Access Compliance Report

Public Rights-of-Way

| Intersection ID: 49102 | Main Street: PROSPERITY_CROSSING_DR | Cross Street: BENFIELD_RD | Location: E |
| ADA ID: 7575CDCC0032 | Ramp Type: Directional1 | Initial Pass/Fail: Pass | Overall Compliance: No |

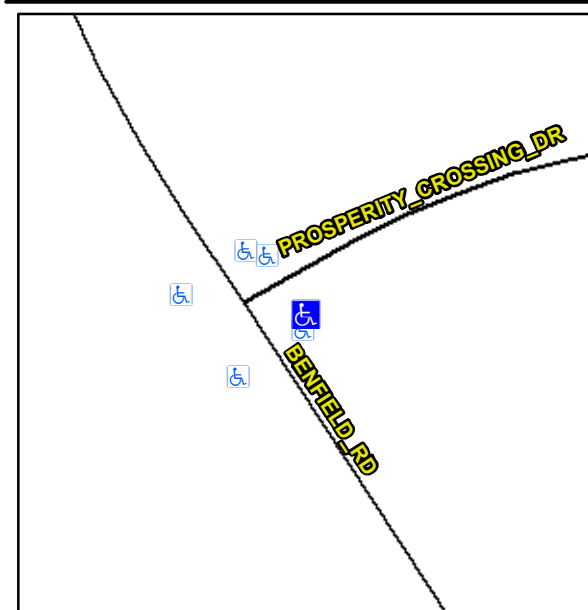
R304.5.4

| Compliance | Description | Data | Compliance | Description | Data |
|------------|-----------------------|-------|------------|-----------------------------|------|
| Yes | Gutter Ponding? | No | No | Gutter Slope (%) | 6.2 |

Remove & Replace Gutter.
